EDGEWATER REDEVELOPMENT

SUBMITTAL PACKAGE
URBAN DESIGN COMMISSION

SUBMITTED BY:
LANDMARK X, LLC
A WISCONSIN LIMITED LIABILITY COMPANY

DESIGN EVOLUTION – INTEGRATION OF UDC COMMENTS

CONFIGURATION OF STAIR

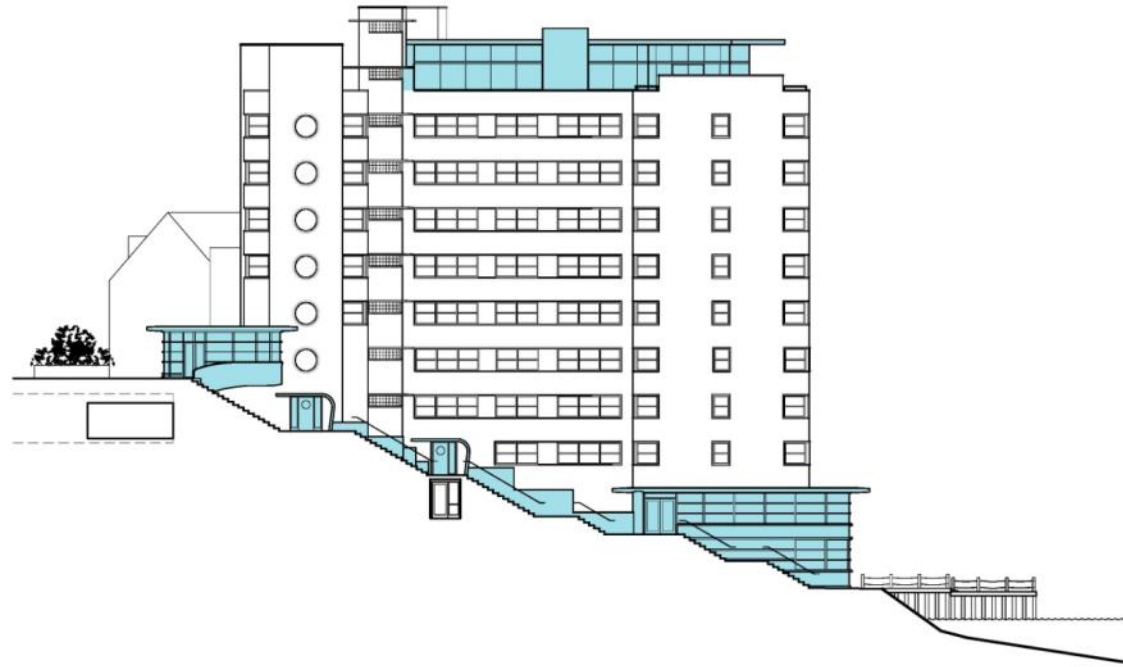
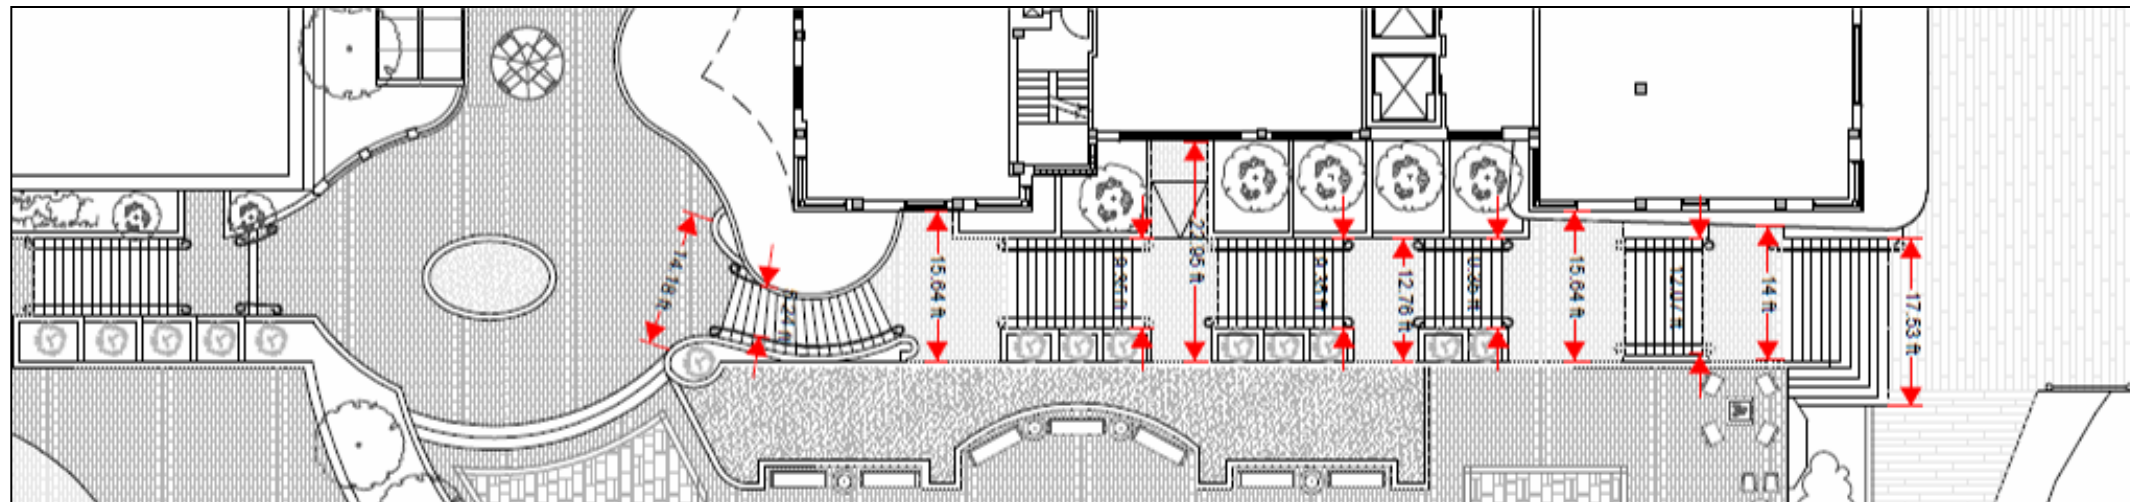
INFORMATION REQUEST – Provide details on the width of the stair, including specific design details.

UDC requested that we study alternate option for stair. An alternate proposal is included above, it responds to UDC comments including:

State Capitol Stair is Approximately 17'-7"

- Stair is integrated with entry features, especially at top canopy;
- Stair treads are widened in certain areas and alternate with planters;
- Stair width is compared against other stairs.

REDUCE BUILDING HEIGHT AND MASS

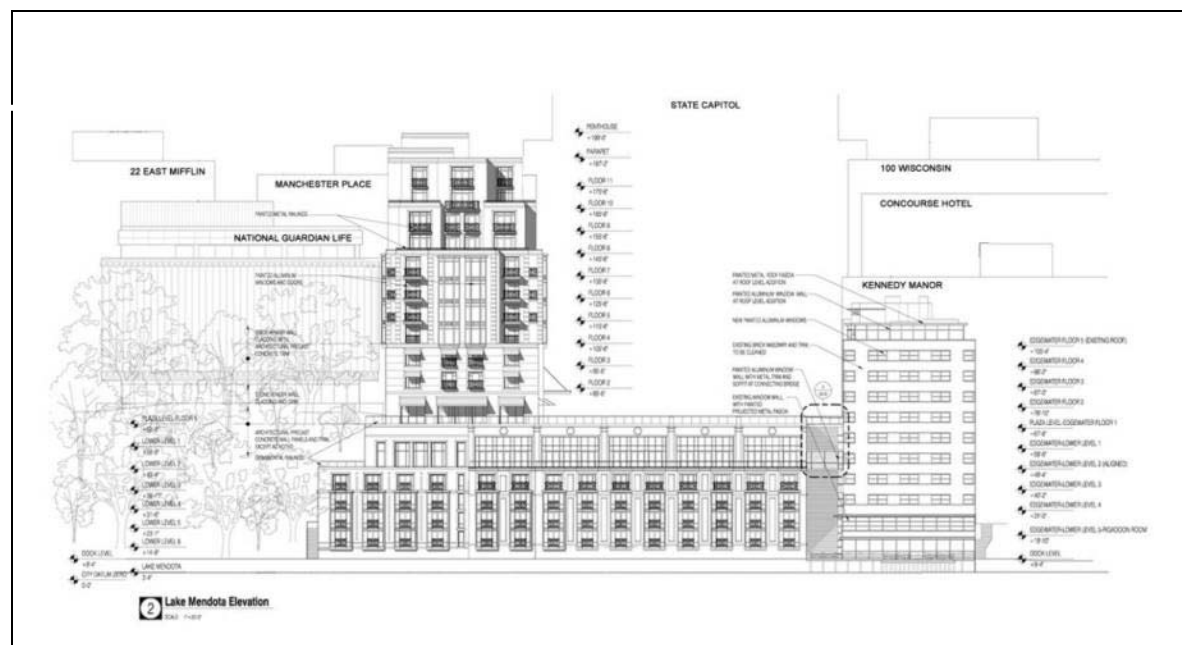
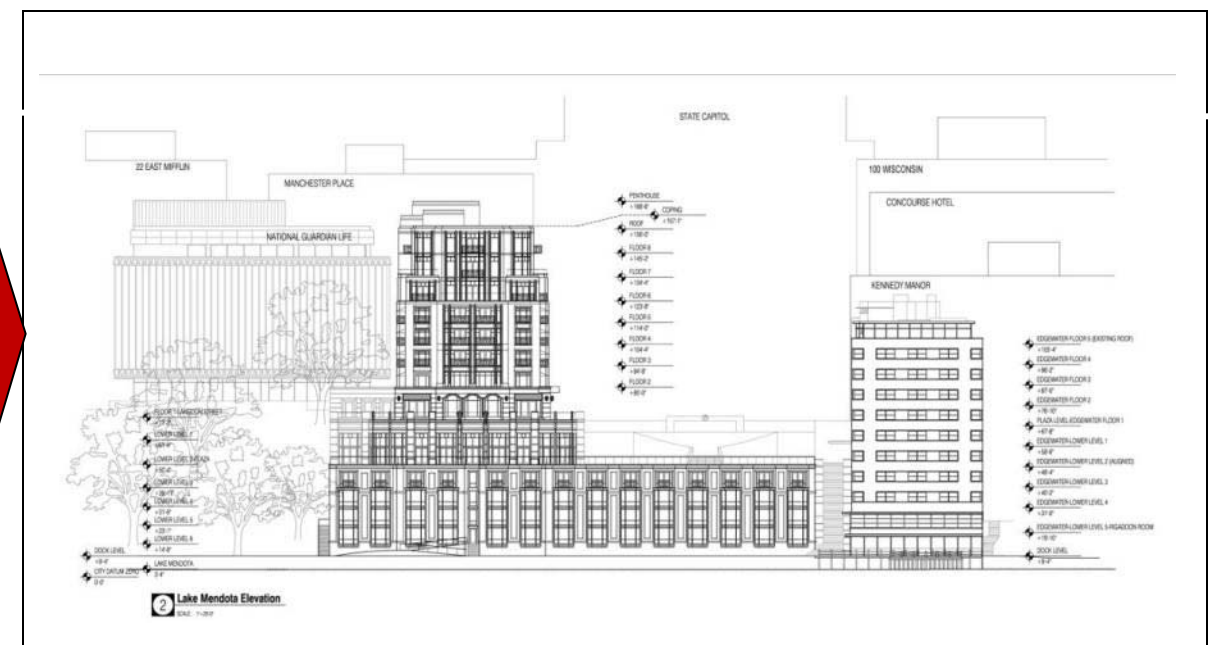
Information Request: Explain how the developer has responded to requests by UDC and others to reduce height and mass off the building.

REDUCED HEIGHT BY 3 FLOORS / 30 FEET

- PRIMARY RESPONSE TO COMMENTS/CONCERNS:**
- » Reduced Height of Tower by 3 Stories, 30 FT;
 - » Reduced the Floor-to-Floor Height on Tower;
 - » Removed 2 Stories, 20 FT of Structure in ROW;
 - » Reduced Total Program by 93,000 SF;
 - » Reduced the Size of the Penthouse;
 - » Removed the need for a Conditional Use Permit for the Penthouse Penetration of Capitol Height;
 - » Better Related Building to Surrounding Context (e.g. NGL / Kennedy Manor)

DENSITY AND FLOOR AREA RATIO

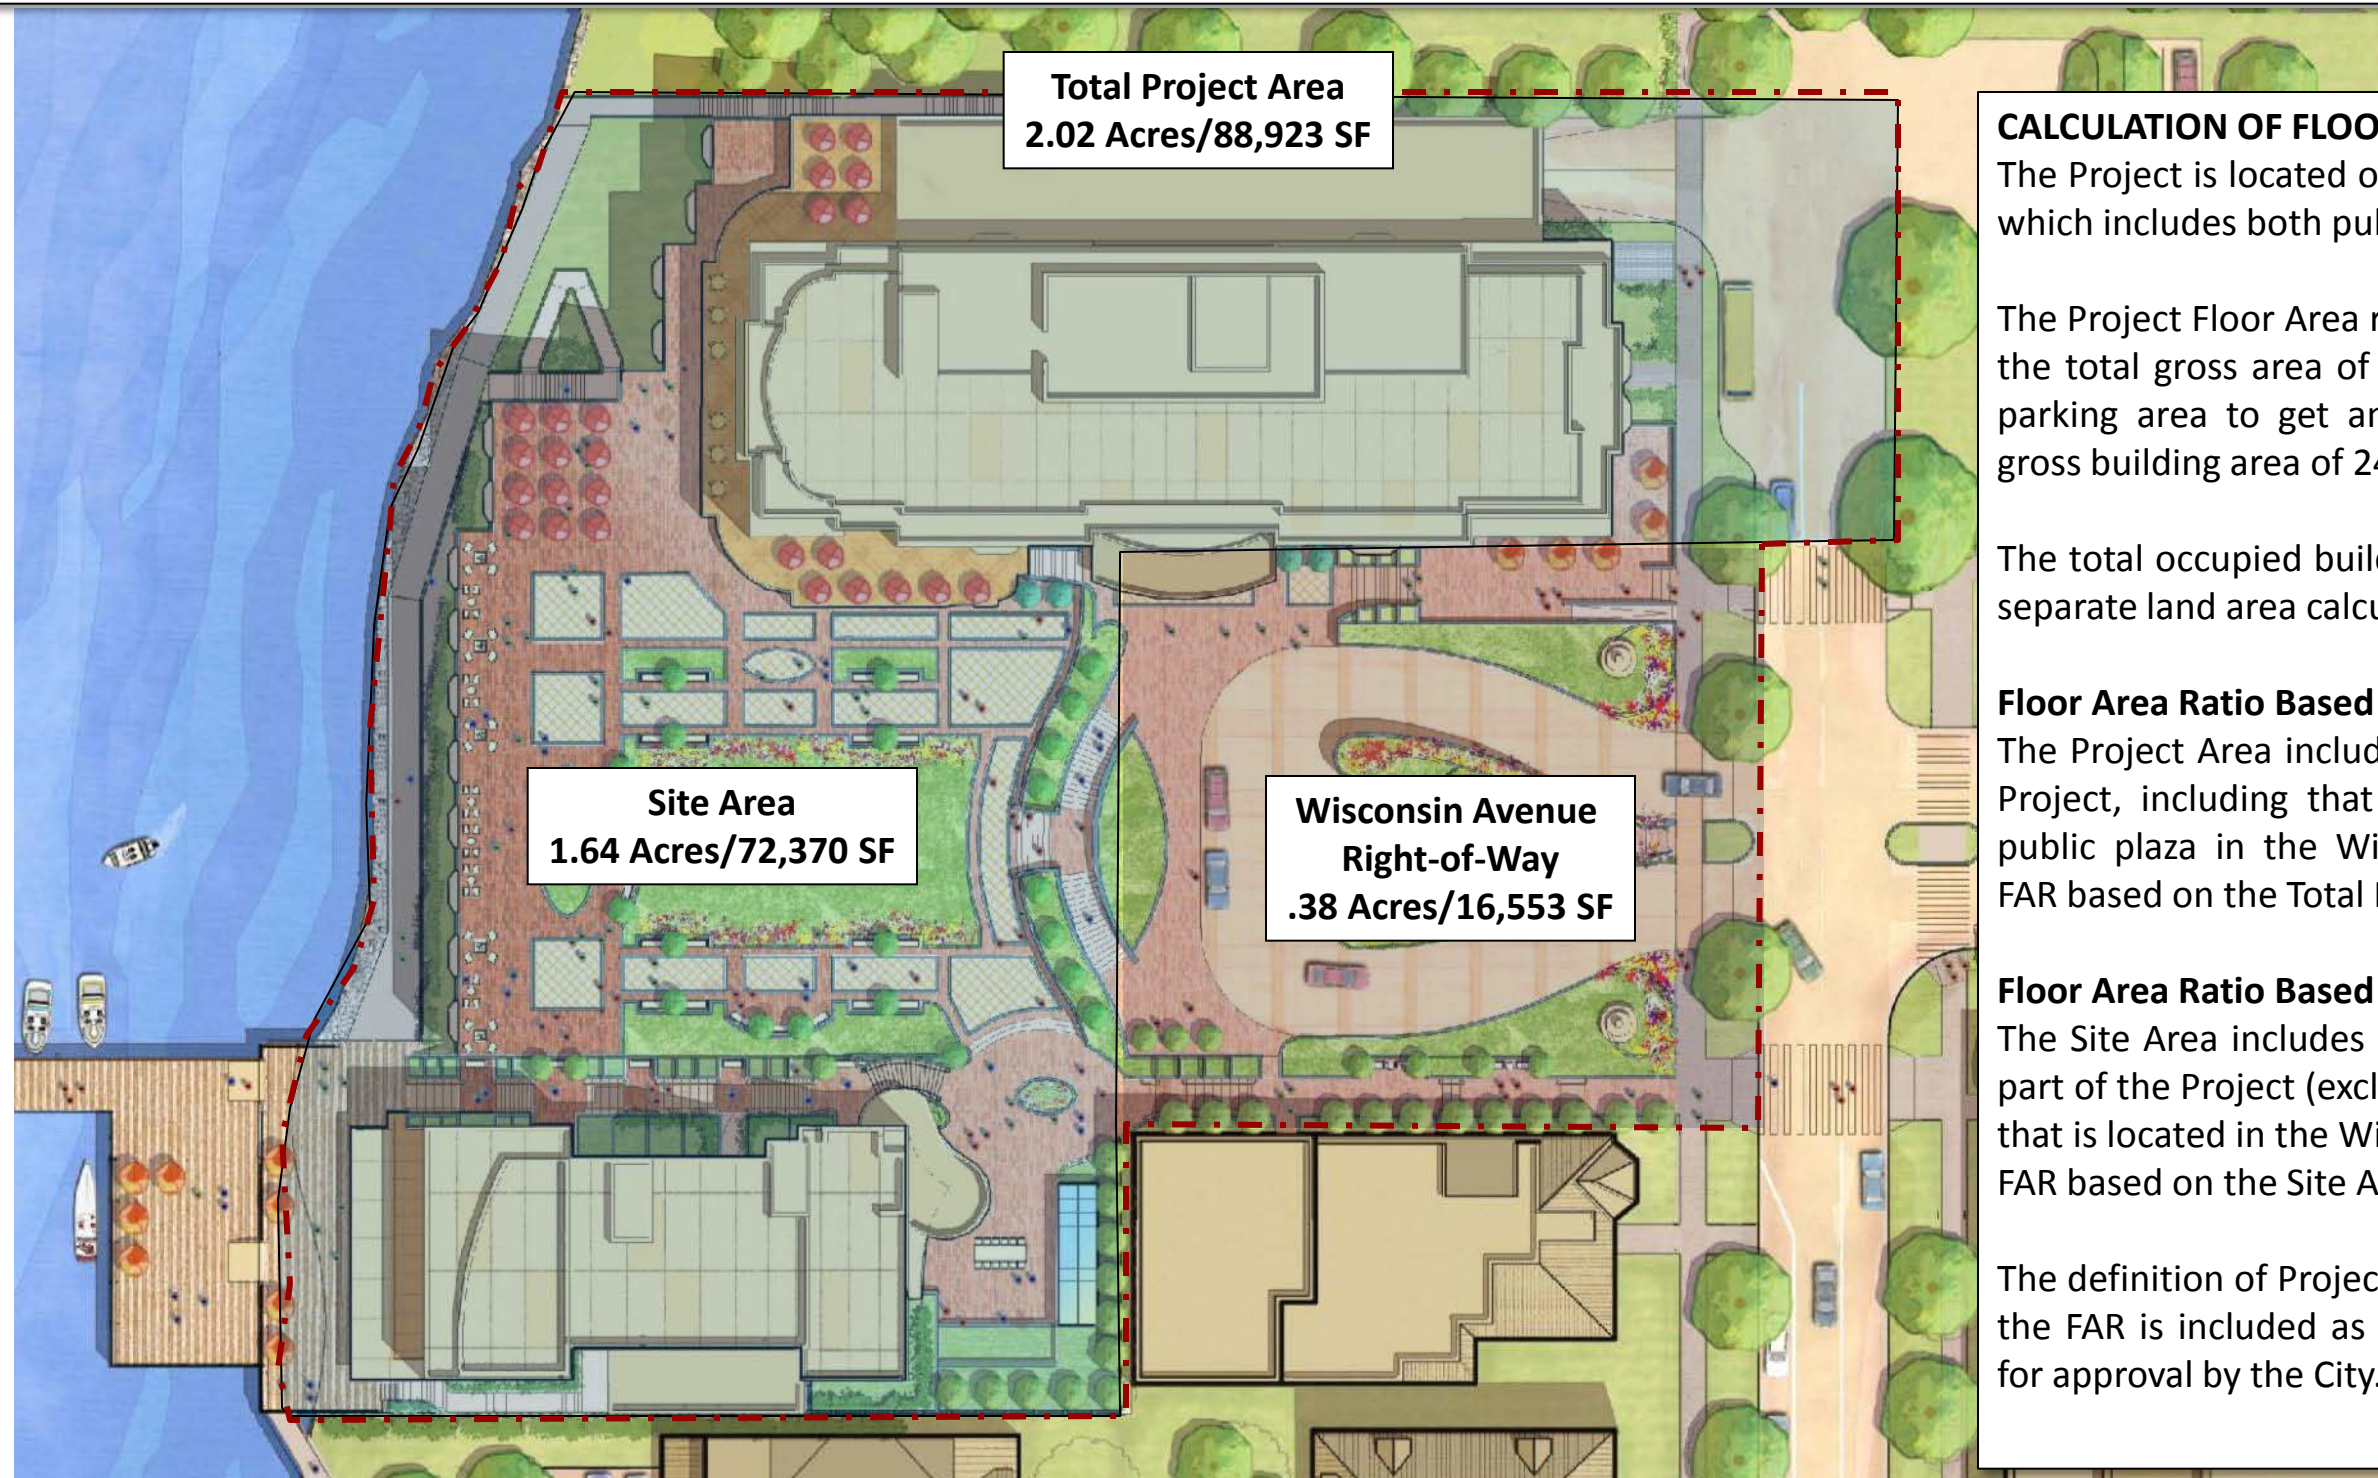
INFORMATION REQUEST: Provide specifics about how the FAR was calculated, clearly identifying the portions of the building and the site that were included. How does this compare to other buildings in the neighborhood and downtown?

The Project is located on approximately 2.02 acres of land which includes both public right-of-way and private land.

The Project Floor Area ratio (FAR) was calculated by taking the total gross area of the building less the below grade parking area to get an estimate for the total occupied gross building area of 249,529 SF.

The total occupied building area was then divided by two separate land area calculations to estimate the FAR:

Floor Area Ratio Based on Total Project Area:

The Project Area includes all land included as part of the Project, including that land which is made part of the public plaza in the Wisconsin Avenue right-of-way. The FAR based on the Total Project Area is estimated at 2.81.

Floor Area Ratio Based on Site Area:

The Site Area includes only the private land that is made part of the Project (exclusive of that portion of the Project that is located in the Wisconsin Avenue right-of-way). The FAR based on the Site Area is 3.44.

BUILDING SETBACK

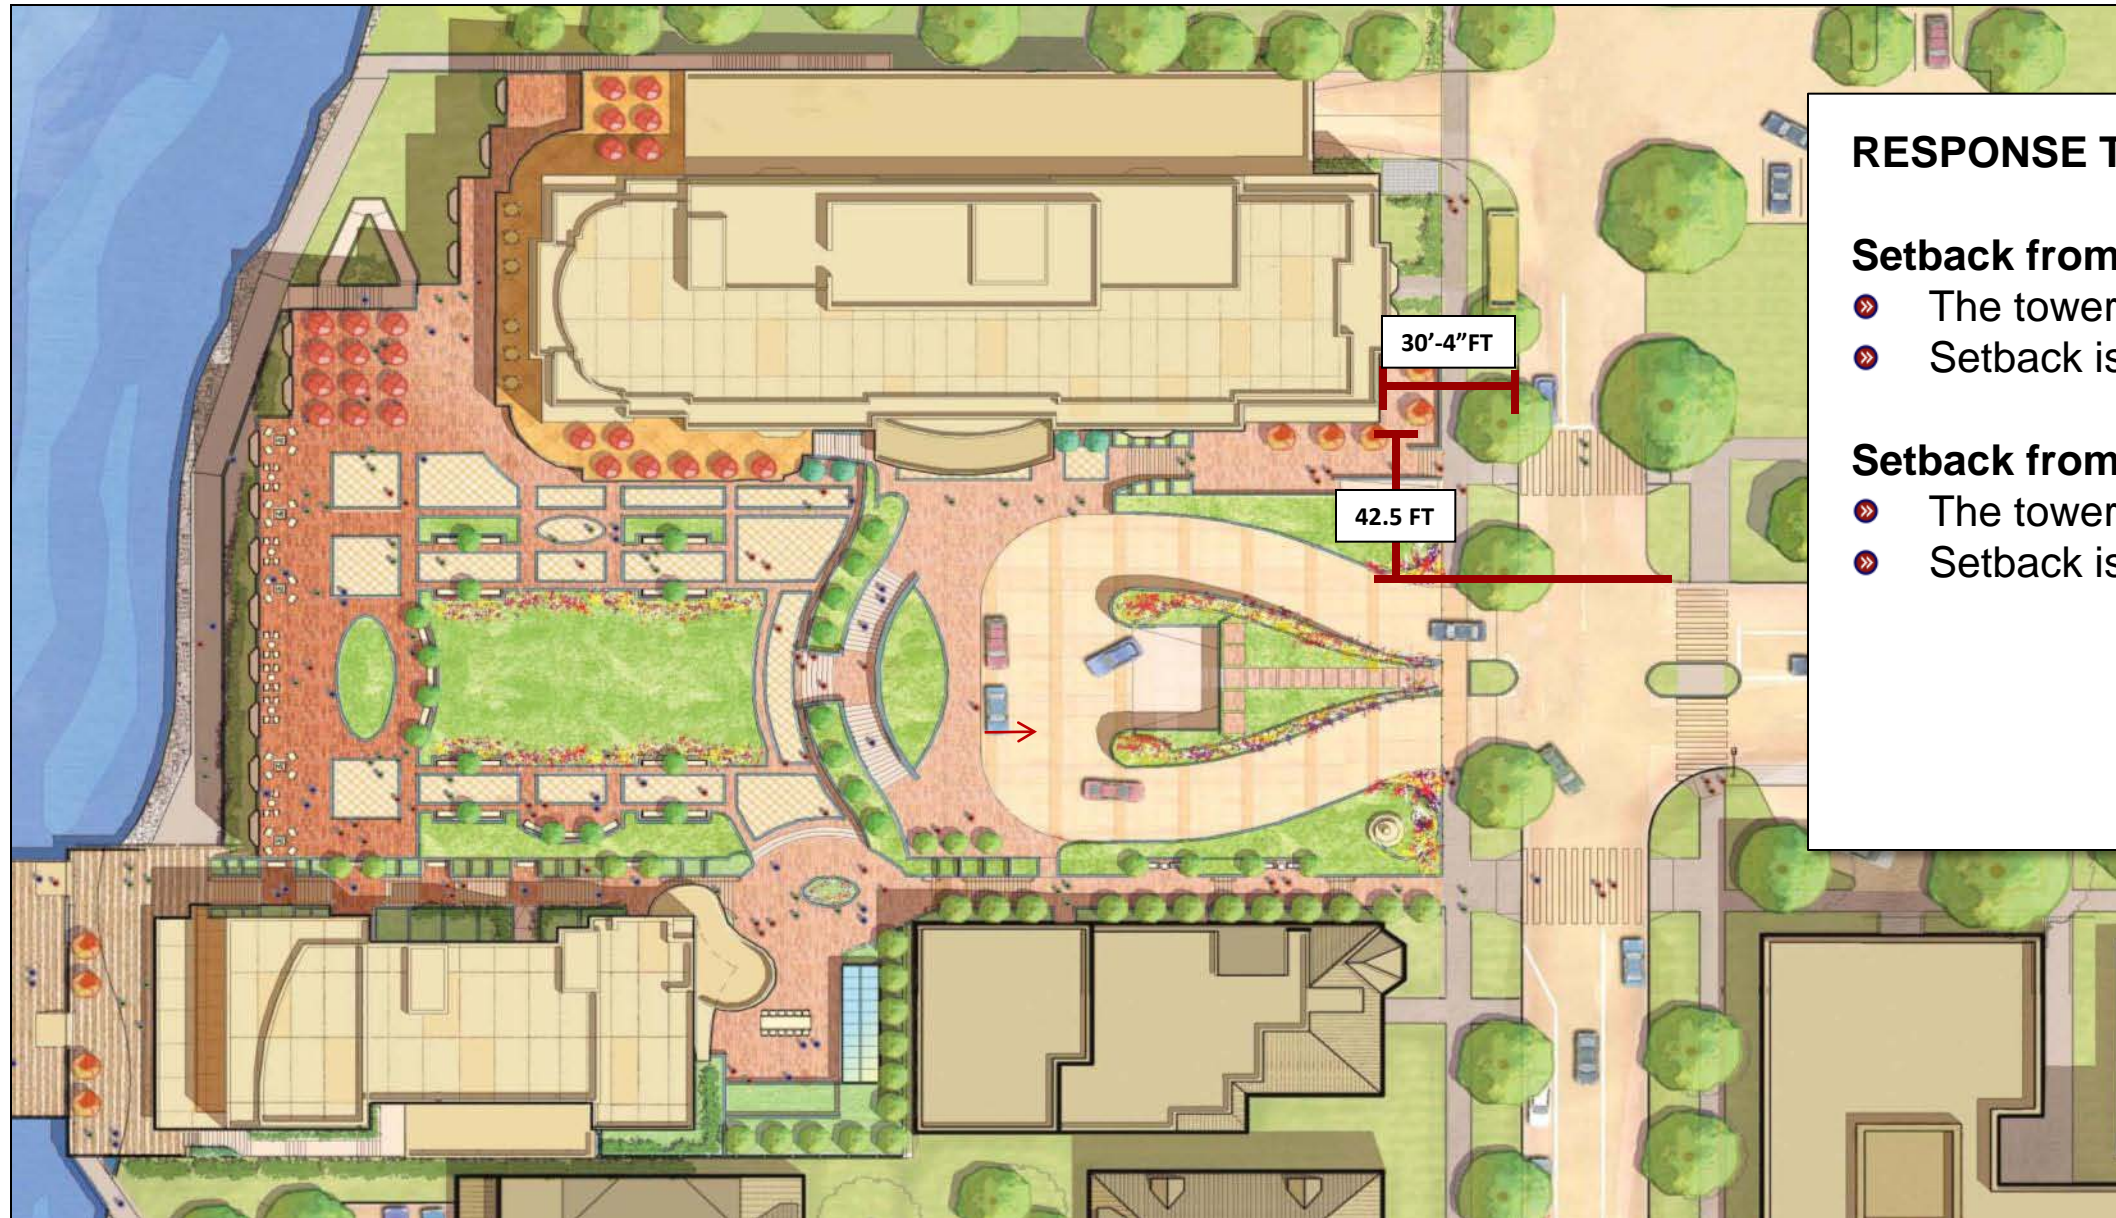
INFORMATION REQUEST: Explain the building setback in relation to the view preservation easement and 1965 Ordinance.

- The buildings are organized around a 132 FT wide view preservation corridor;
- The setback from the view preservation corridor is consistent with build-to line of 2 Langdon and Edgewater;
- The Ordinance that established in the 1970's street vacation required a 10 foot setback for any building built above the existing premises. The area impacted by this setback is highlighted in the adjacent plan.

The setback provision in the Ordinance is only “reserved to the extent reasonably necessary and appropriate to assure the permanent benefit of the general public”.

The adjacent plan highlights the area where structure is removed from the 1970's building as compared to the area where the 10 FT easement may be applied to the building. The impact of removing the 1970's building far outweighs the impact of a 10 FT setback and this attention will greatly enhance the existing conditions and exceed the intent of the language of the Ordinance..
